TECHNICAL BULLETIN
Q637 UPS7716-4bNAS1
13 OCT 2016

Update Prior to Sale: USA Battery Legal Label

E198776

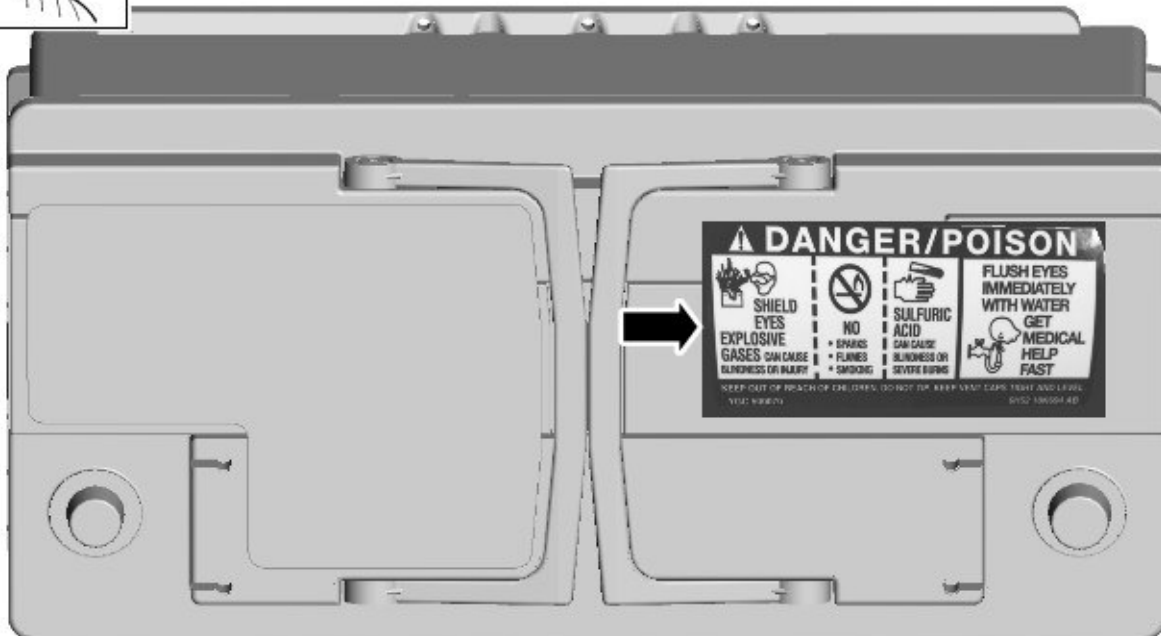
Situation: An issue has been identified on the one vehicle within the listed Affected Vehicle Range where a replacement battery has been fitted without the required USA legal label.

1. Visually check if the battery warning label is installed as shown.
 - If the battery warning label is installed, release the vehicle.
 - If the battery warning label is not installed, install a new battery warning label as shown.
